Project:
Bourne Estate South for Higgins Construction PLC

Drawing title:
BLOCK 1
North & Northwest Elevation

P280

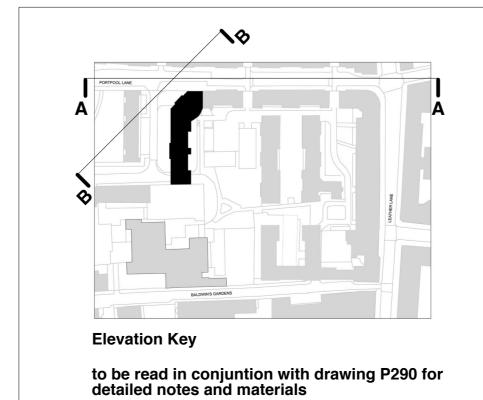
2015.08.17 **E** Condition 6 re-submission
Vent positions moved from
Elevation A to Elevation B
Brick cornice revised

2015.04.24 **D** Condition 6 submission
Vents, rainwater pipes and flues
added

2014.09.15 **C** Relocation of north core bin store
to Portpool Lane elevation;
window positions to community

to Portpool Lane elevation; window positions to community hall revised; signage position revised and combined with basement grilles; large opening to fifth floor stair revised as stair now terminates at 4th floor.

2014.02.12 **B** Storey height increased, mansard roof angle adjusted 2013.02.08 **A** Plinth height increased to 2 storeys
